23/1237/RES Phase 3 And Seabrook Square, Exeter Cycling Campaign Response

The Exeter Cycling Campaign is grateful for the opportunity to respond to the planning application 23/1237/RES Phase 3 And Seabrook Square and offers the following comments.

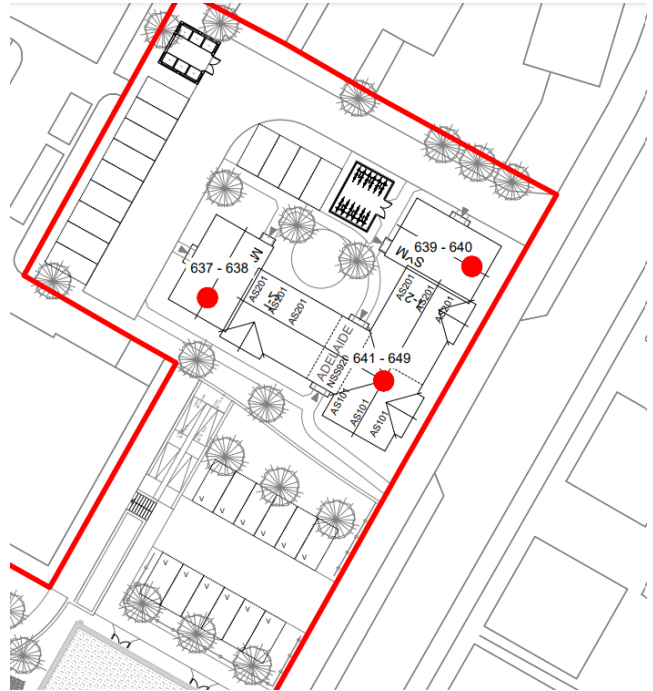
We have concerns about the locations of the cycle parking for Seabrook Square. The NPPF paragraph 29 lays out that *“the transport system needs to be balanced in favour of sustainable transport modes, giving people a real choice about how they travel”*. We are unsure whether the cycle shed at the north end of the Square is for residents or visitors to the community building. If the former and not the latter then there is no safe, easily-accessible cycle parking for visitors to the community hall. Can this omission please be corrected. See [LTN 1/20](#) section 11 for standards for cycle parking.

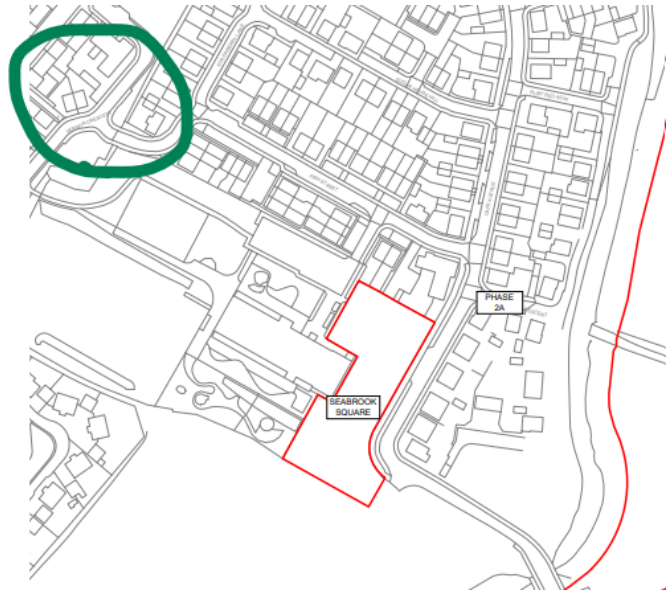
Active travel link: We were heartened to read on the DAS that “A pedestrian and cycle link is provided in the NE corner of the site onto the existing network at Newcourt Road” but are struggling to see this explicitly confirmed in the drawings. Can we clarify that this pedestrian/cycle link (circled in red) is this link?

Link to Admiral Way: There is currently no access/egress from Dart Ave onto Admiral Way (blue circle). We understand this to be because of a condition based upon a condition of occupancy of an earlier application requiring it to be opened prior to the occupation of not more than 650 dwellings. We would ask that this occupancy level is accessed and, if the condition met, action taken to open this for active travellers so that there is a reasonable route from the Phase 3 development NE along Admiral Way to the shop and Newcourt community hall.

Fish Street ransom strip: the access to Fish Street from Vernon Crescent has recently been blocked. (green circle). This created particular difficulties for children and parents travelling by foot, scooter or bike from Newcourt to the school and safely onto Topsham. This requires urgent attention to unblock again and we would ask that this is included in the design / consenting / contributions for this development.

The Topsham Millenium Wood will be an important natural space for residents on this Phase 3 development. It is not clear what the access to this wood will be. The drawings are not clear. Can it be confirmed that there will be three (shown in red circles) access points to the wood?
